11-1 CHECKING PRESTRESS SHOP DRAWINGS

Consider a two-span CIP/PS box girder bridge with skewed supports and horizontal curvature.

Figure 8 - Duct Profile

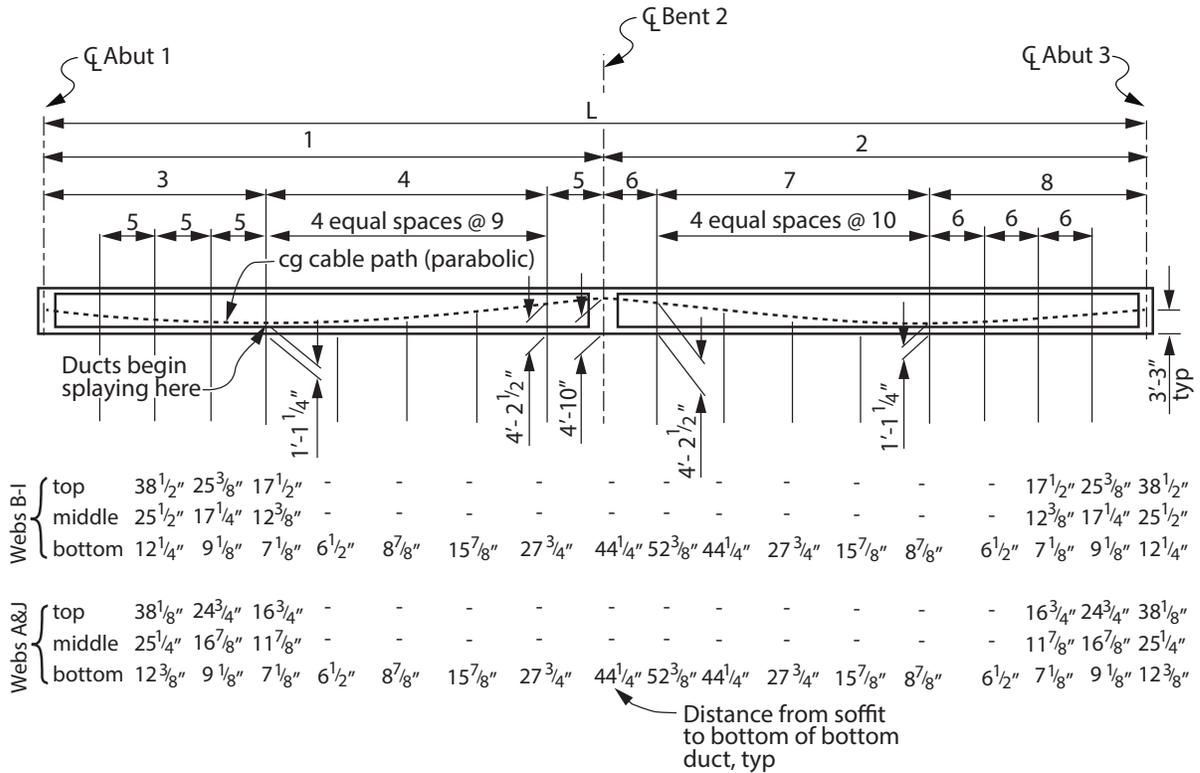
STEP 1: Compare the control points along the cable path c.g. (Fig. 8) with the structure plans (Fig. 7).

The vertical dimensions to compare in this example are: 3'-3", 1'-1 1/4", 4'-2 1/2", and 4'-10". These values must compare exactly, and in this case they do. Be sure to highlight each checked item on the shop plans file copy as you proceed. (Fig. 9)

The layout is provided in Figure 8 which represents the shop plan duct profile as provided to the Engineer. The c.g.s. of each control point was already checked in step 1. Now check the LOL for each of these control points (use calculated values). The tolerance is $\frac{1}{4}$ ".

- Span 1 low point: $13.25" - 6.72" = 6.53"$ 6.50" provided, OK
 - Span 1 inflection point: $50.5" - 6.21" = 44.29"$ 44.25" provided, OK
 - Bent 2 high point: $58" - 5.69" = 52.31"$ 52.38" provided, OK
- Span 2 locations are the same by symmetry.

Figure 8 anchorage location = 3'-3" (39"). The anchorage layout is OK.

Figure 12 - Stressing Sequence (Shop Plan Drawing)

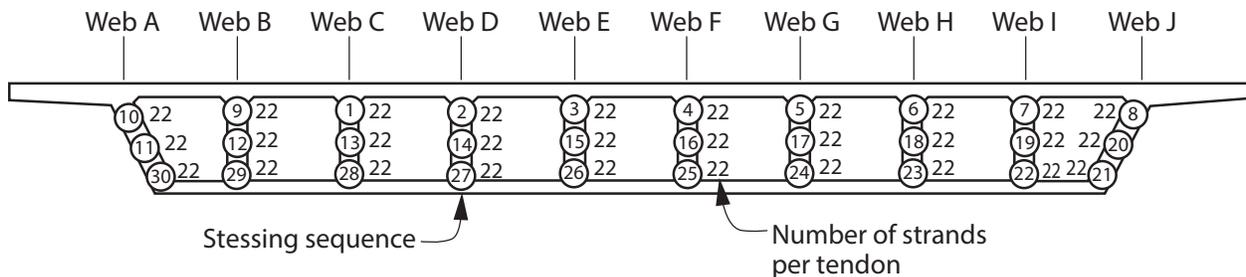
Additionally, check to make sure the chosen number of strands and tendons adds up to the required total. For this check, use the stressing sequence drawing (Figure 12).

$$No.strands = 28 * 22 + 2 * 24 = 664 \text{ strands} \quad \text{OK}$$

Finally, the check of item 3) for temporary force variation can be done by inspection. Looking at Figure 12, the maximum number of strands is 24 in webs E and F. So long as any one girder does not have more than a 24 strand difference from any other girder during any given sequence, this criteria is met. By inspection, the maximum variation occurs after sequence 25. At this moment in time, girder E will have a 24 strand difference from girders A-D and F. This is the maximum difference allowed so it is OK.

Figure 13 - Average C.G. from LOL Checked (Shop Plan Drawing)

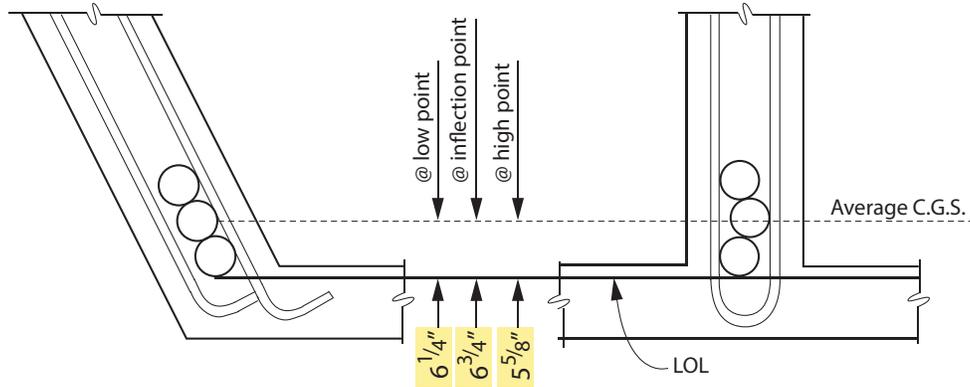
$$\text{cg@ low point} = (2[22(\frac{4.2}{2} + 0.5) + 22(\frac{4.2}{2} + 3.76 + 0.5) + 22(\frac{4.2}{2} + 3.76 + 3.76 + 0.5)] + 6[22(\frac{4.2}{2} + 0.5) + 22(\frac{4.2}{2} + 4.17 + 0.5) + 22(\frac{4.2}{2} + 4.17 \times 2 + 0.5)] + 2[24(\frac{4.45}{2} + 0.71) + 22(\frac{4.45}{2} + 4.31 + 0.5) + 22(\frac{4.45}{2} + 4.31 + 4.17 + 0.5)]) / (664 \text{ strands}) = 6.72 \text{ in}$$

$$\text{cg@ inflection point} = (2[22(\frac{4.2}{2}) + 22(\frac{4.2}{2} + 3.76) + 22(\frac{4.2}{2} + 3.76 + 3.76)] + 6[22(\frac{4.2}{2}) + 22(\frac{4.2}{2} + 4.17) + 22(\frac{4.2}{2} + 4.17 \times 2) + 2[24(\frac{4.45}{2}) + 22(\frac{4.45}{2} + 4.31) + 22(\frac{4.45}{2} + 4.31 + 4.17)]) / (664 \text{ strands}) = 6.21 \text{ in}$$

$$\text{cg@ high point} = (2[22(\frac{4.2}{2} - 0.5) + 22(\frac{4.2}{2} + 3.76 - 0.5) + 22(\frac{4.2}{2} + 3.76 + 3.76 - 0.5)] + 6[22(\frac{4.2}{2} - 0.5) + 22(\frac{4.2}{2} + 4.17 - 0.5) + 22(\frac{4.2}{2} + 4.17 \times 2 - 0.5)] + 2[24(\frac{4.45}{2} - 0.71) + 22(\frac{4.45}{2} + 4.31 - 0.5) - 22(\frac{4.45}{2} + 4.31 + 4.17 - 0.5)]) / (664 \text{ strands}) = 5.69 \text{ in}$$

Figure 14 - Anchorage Area PT Duct Layout (Shop Plan Drawing)

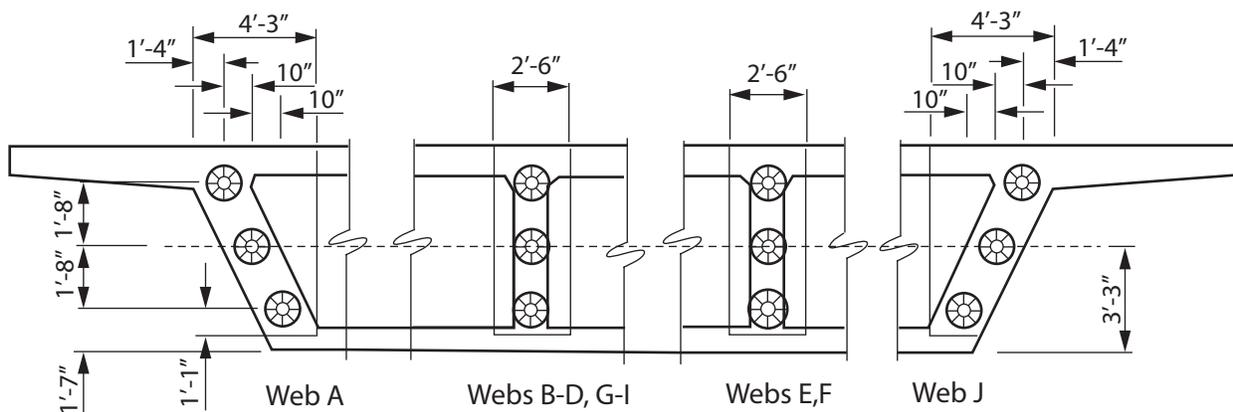
Next, check the c.g.s. at the anchorage areas. The goal here is to make sure the anchorage layout on the shop drawings (Figure 14) matches the Figure 8 dimensions.

$$\text{Anchorage Area cg} = \frac{[19(22 \times 8 + 24 \times 2) + 39(22 \times 10) + 59(22 \times 10)]}{664} = 38.88''$$

Figure 15 - Cable Path Parabolas at Web E

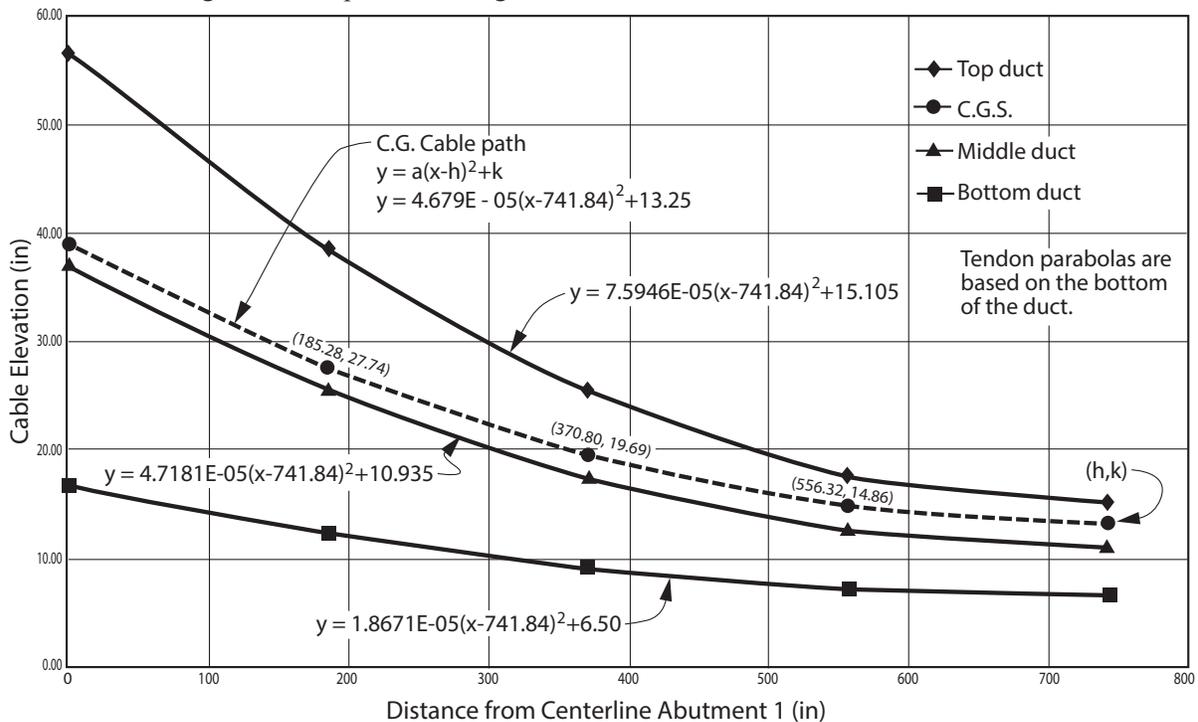
To check the shop drawing value for each tendon, create parabolas for each tendon using the known end points. The first intermediate point is at location $x = 185.28$. For the bottom duct the vertical profile at this location is:

$$y = 0.000018671 * (185.28 - 741.84)^2 + 6.50 = 12.28 \text{ in}$$

The shop drawing value is $12 \frac{1}{4}''$. Value checks out OK.

$$y = 0.000018671 * (370.80 - 741.84)^2 + 6.50 = 9.07 \text{ in}$$

The shop drawing value is $9 \frac{1}{8}''$. Value checks out OK.

$$y = 0.000018671 * (556.32 - 741.84)^2 + 6.50 = 7.14 \text{ in}$$

The shop drawing value is $7 \frac{1}{8}''$. Value checks out OK.

$$y = 0.000043895(231.84)^2 + 6.5 = 8.86 \text{ in}$$

Shop plan value is $8 \frac{7}{8}''$, value checks out OK.

Figure 16 - Bearing Plate Angle

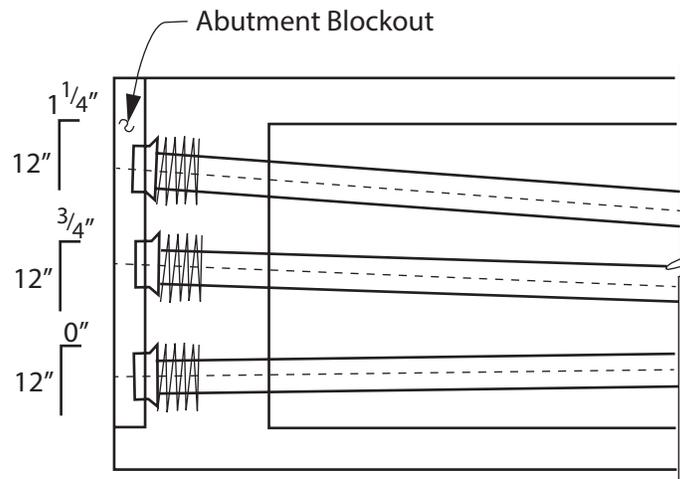
$$y = 1.867E-05 (x-741.84)^2 + 6.50$$
$$\frac{dy}{dx} (\text{at } x = 0) = 2 * 1.867E - 05 (0-741.84) = -0.0277$$

The net slope of the bottom duct is therefore: (-0.0277+0.01479) = -0.0129.

The shop plans indicate 0. The percentage difference is 1.29% < 2.0%, this checks OK.

$$\text{Net slope} = -0.0700 + 0.01479 = -0.0552$$

The shop plans indicate -0.75"/12" = -0.0625. The percentage difference is (0.0625-0.0552)*100 = 0.73% < 2.0%. This checks OK.

$$\text{Net slope} = -0.113 + 0.01479 = -0.0982$$

The shop plans indicate $-1.25''/12'' = -0.1042$. The percentage difference is $(0.1042-0.0982)*100 = 0.6\% < 2.0\%$. This checks OK.

Figure 17 - Plan View Blockout Dimensions (Shop Plan Drawing)

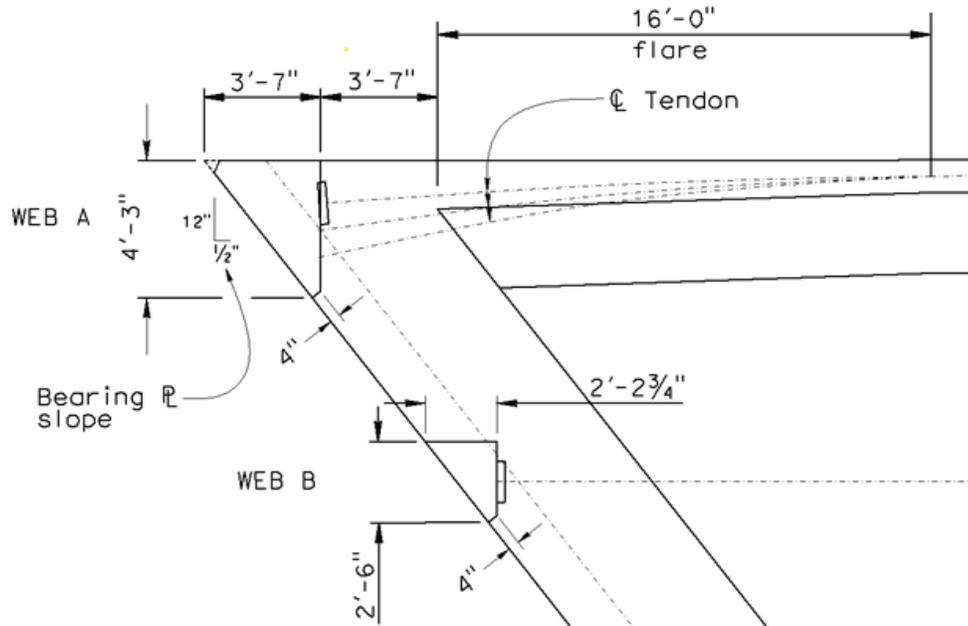
In Figure 17, dimensions are provided on the shop drawings indicating the depth of the breakout as well as the horizontal slope of the bearing plate, if any. For Web A, a horizontal slope is necessary (relative to the plane of the breakout) because at exterior girders the path needs to curve inward to allow enough room for the anchorage hardware and edge distance.

WEB A: $Blockout\ Depth = (4.25 + 0.333) * \tan(37.898) = 3.57ft$
3'-7" was provided, OK.

WEB B: $Blockout\ Depth = (2.5 + 0.333) * \tan(37.898) = 2.21ft$
2'-2 3/4" was provided, OK.

$$\tan^{-1}\left(\frac{1.333\ ft - 0.5\ ft}{19.58\ ft}\right) = 2.44^\circ$$

Provided: 1/2" in 12" = 2.38°, OK.

Figure 18 - Single Span Bridge Longitudinal Section (Shop Plan Drawing)

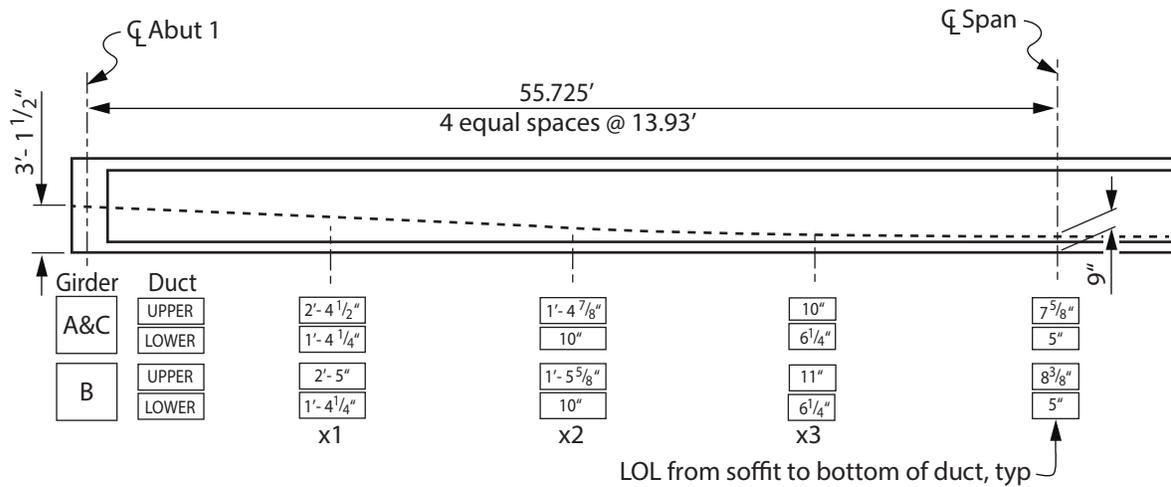
For this single span bridge example, the cable path is symmetrical about the centerline of the span. When shop plans use this format, one needs to compare the c.g.s. location based on the structure plans to the c.g.s. as located by a weighted average of the dimensions provided in the boxes (based on the PS shop plans). One method to perform this check is shown in Figure 19.

The soffit to c.g.s. using the shop plans is calculated by using a weighted average of the strand layout line locations provided. Take into account the diameter of the duct and the “z” value for each duct size. Tolerance is $\frac{1}{4}$ ”.

The profile of each individual duct may not be parabolic, therefore, plot the layout of each tendon on a graph to ensure there are no kinks in the profile.
